G-5275

Subject: **PLAN REVIEW – MINIMUM RISK STATEMENT**  
Proposed New Residence  
38XX West Mercer Way  
Mercer Island, Washington 98040

Ref: “Geotechnical Engineering Study, Proposed New Residence, 38XX W Mercer Way, Mercer Island, Washington 98040, G-5275, GEO Group Northwest, Inc., November 2, 2020.”

**EXCAVATION PLAN**  
 PROPOSED NEW RESIDENCE  
 38XX W MERCER WAY  
 MERCER ISLAND, WASHINGTON

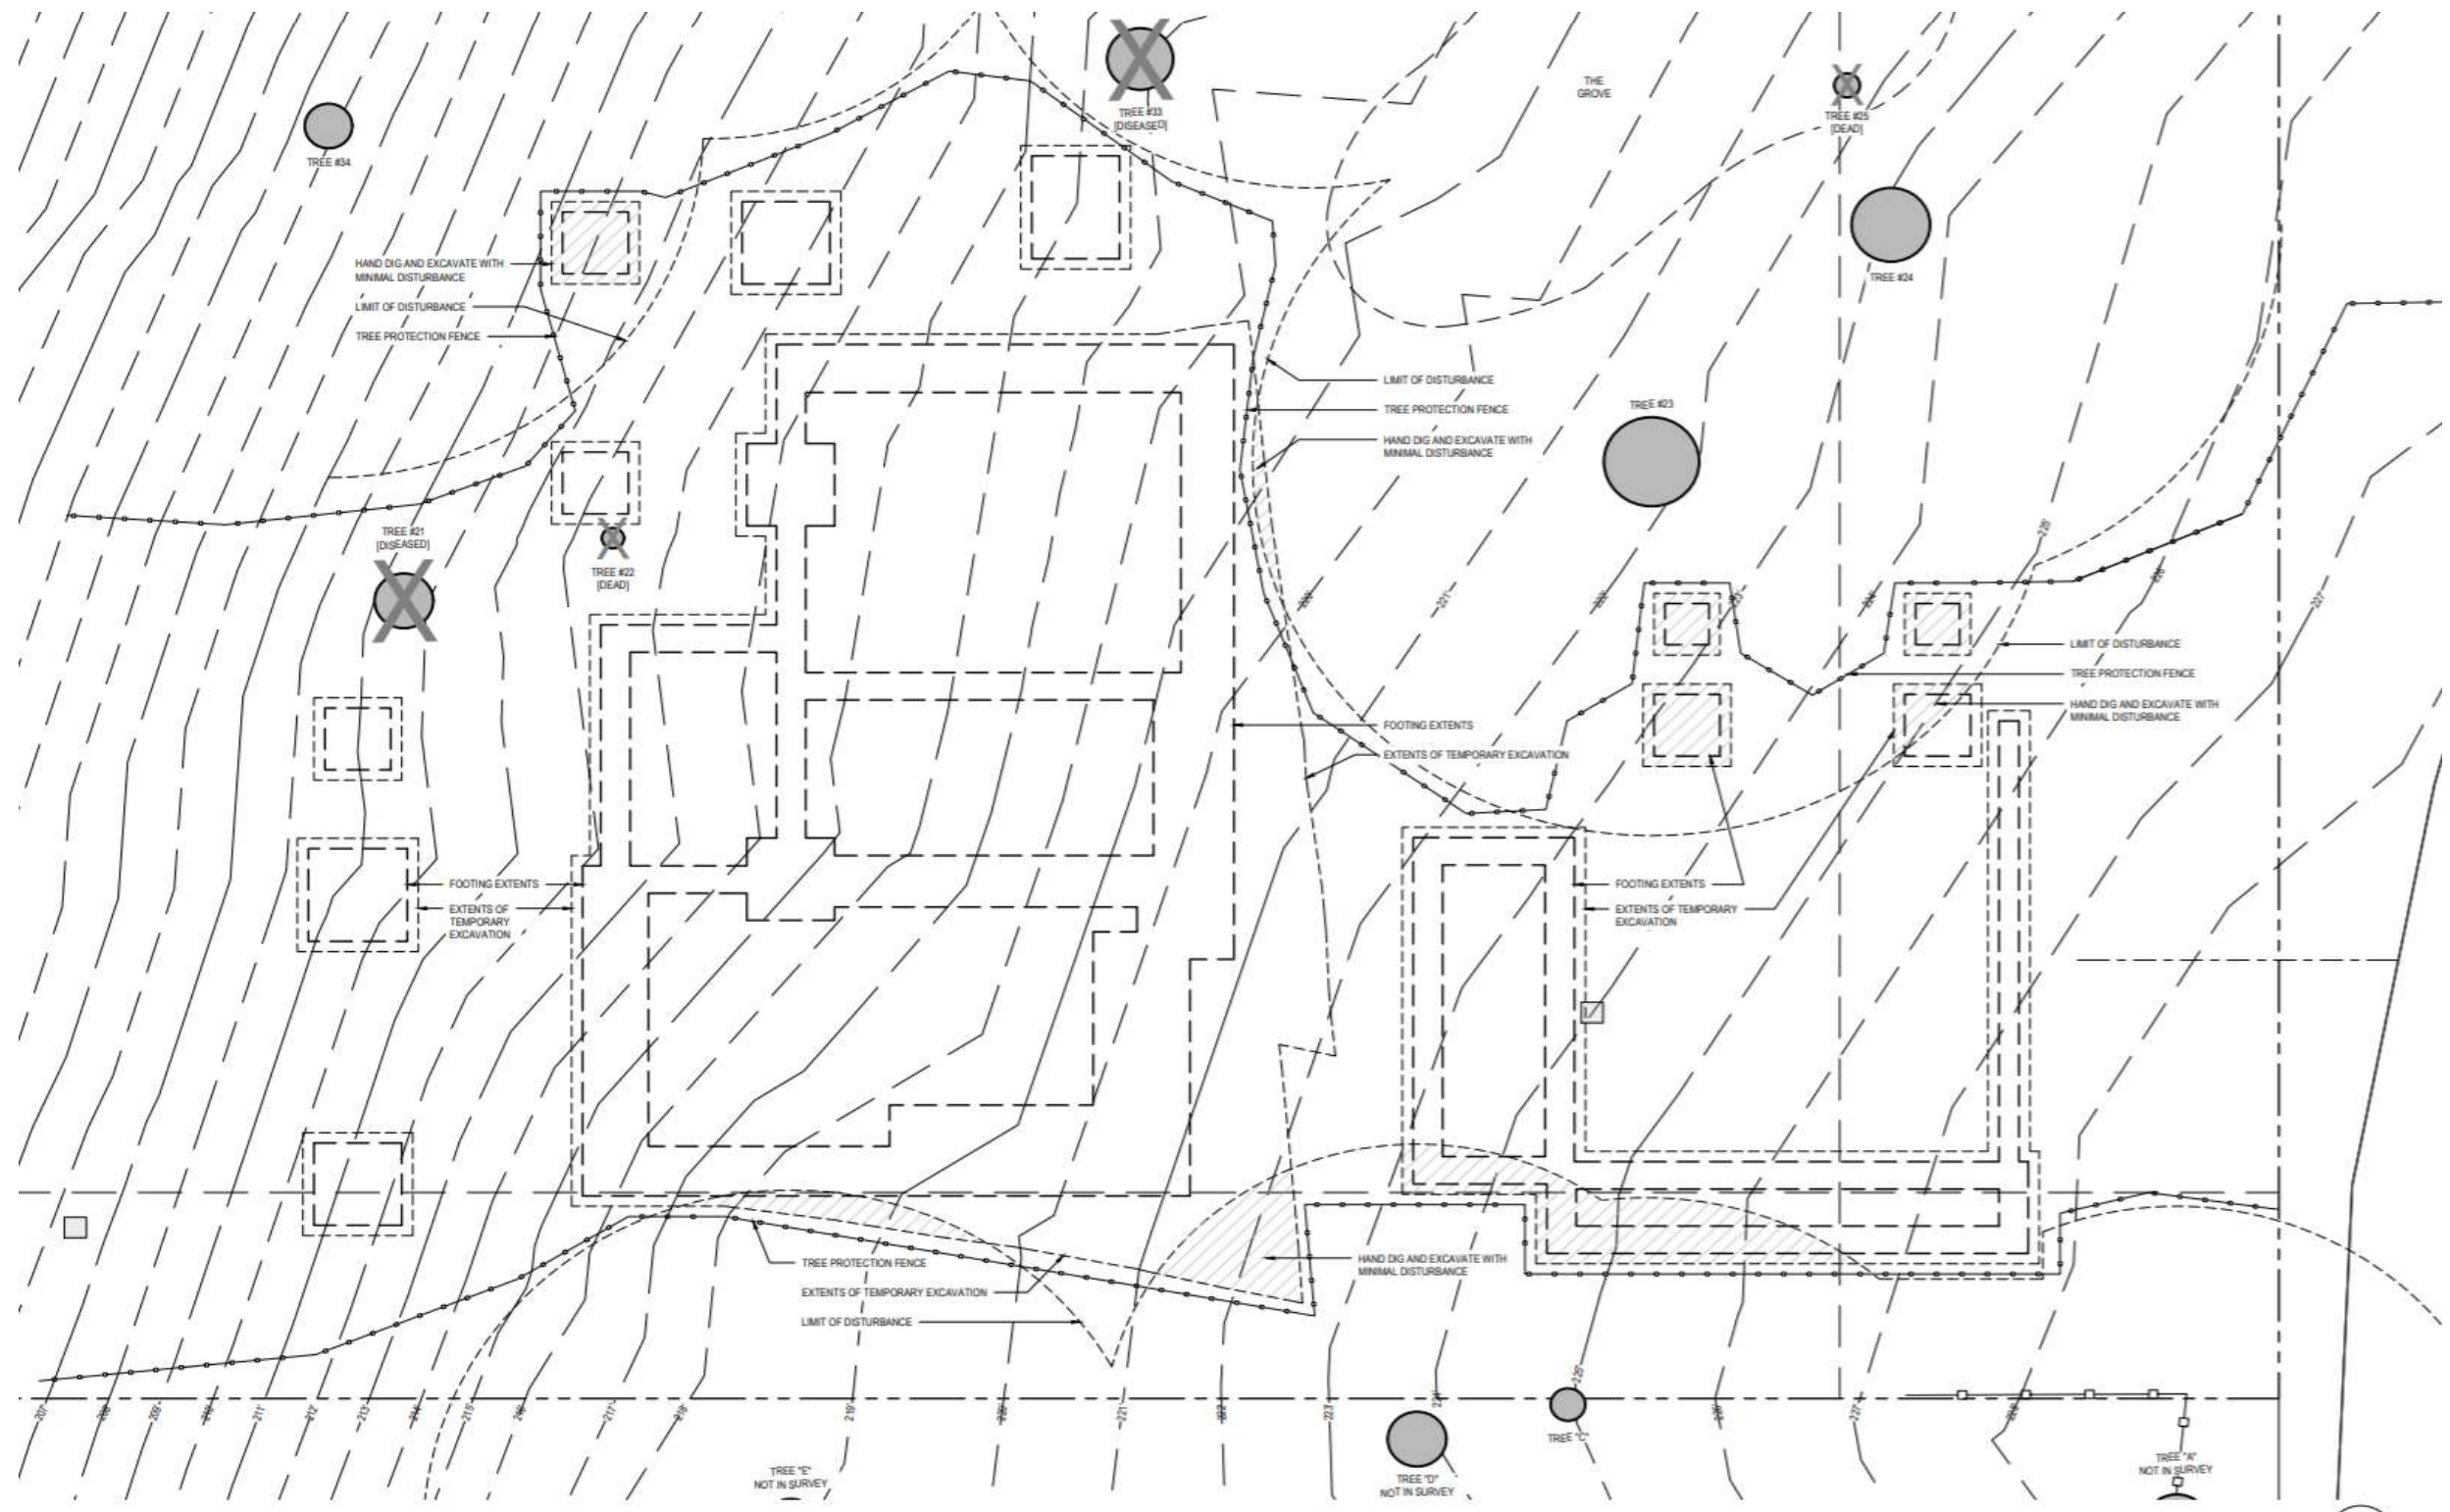
Temporary excavations for the proposed new residence’s foundations are shown to be conducted at 1H:1V cuts with unsupported vertical cuts having heights no greater than 4 feet. The proposed developments were designed such that the carport would be located on relatively flat topography and the finished grade for the new residence would achieve minimal alterations to the existing contours located at the northeast section of the property. Erosion control for the project includes silt fencing along the full perimeter of the work area, with the limit of disturbance extending no further than the foundation perimeters. The excavation plans also illustrate the necessary removal of dead or diseased trees and protective fencing for retained trees throughout the property. The excavation plan for the proposed development is shown in Plate 2 – Excavation Plan.

We have reviewed the final set of project plans and have verified that they comply with the recommendations outlined in our referenced geotechnical report. The plans show that temporary vertical excavations for the residence basement wall foundations will have maximum heights of 4 feet while other cuts will have inclinations of 1H:1V. The residence was designed such that the proposed alterations to the existing site topography have been minimized and the potential

### CRITICAL AREAS MAPPING

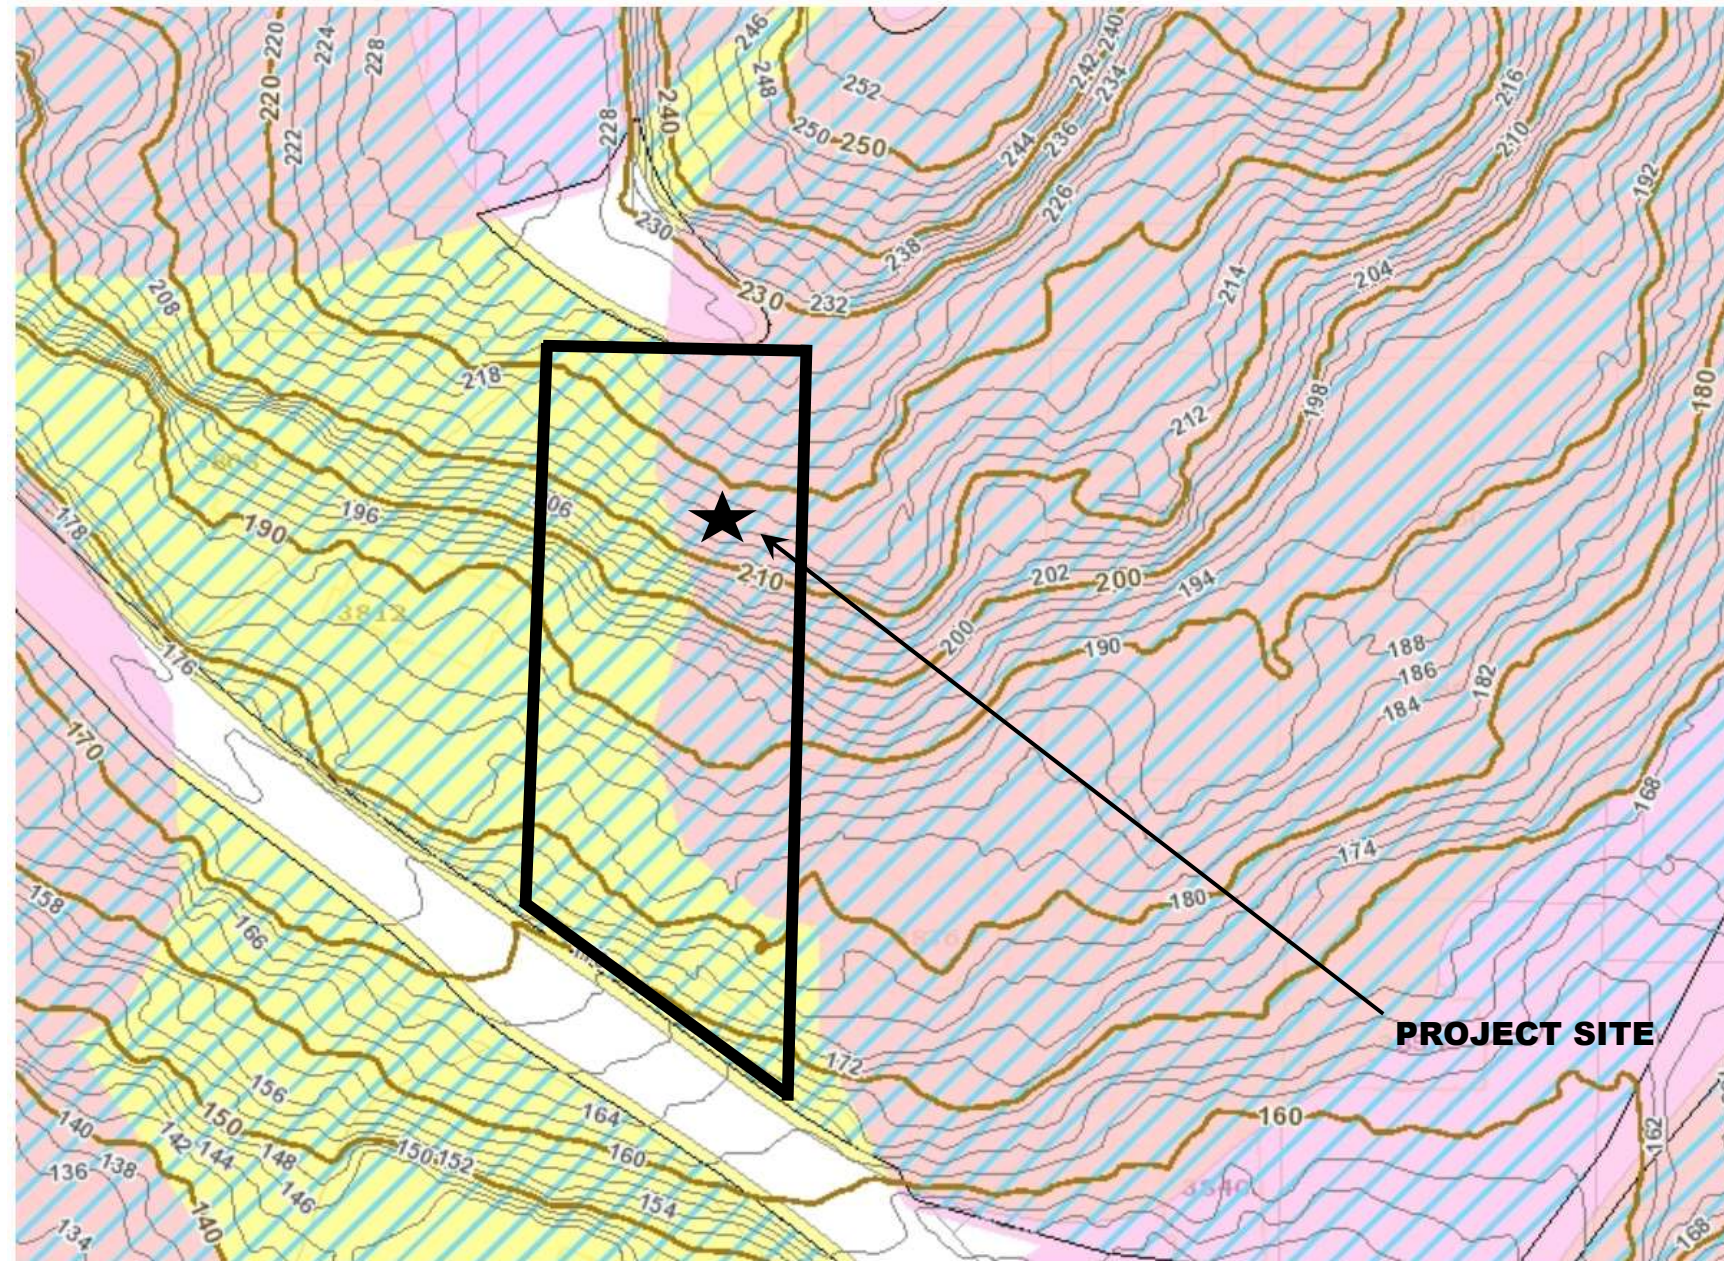
19.07.160.A of the Mercer Island City Code (MICC) designates geologically hazardous areas as being either erosion hazard areas, landslide hazard areas, and seismic hazard areas. According to the Mercer Island Online GIS Portal, the above-subject property is mapped as being within a landslide hazard area and erosion hazard area, and containing a seismic hazard area near its east property line. The mapping of the geologically hazardous areas present at the project site is illustrated in Plate 3 – Critical Areas Mapping. During our site reconnaissance and subsurface investigation on October 16, 2020, described in more detail in our above-referenced geotechnical report, we did not encounter evidence that the project site may be susceptible to the risks associated with erosion, landslide, or seismic hazards or that the proposed scope of work for the
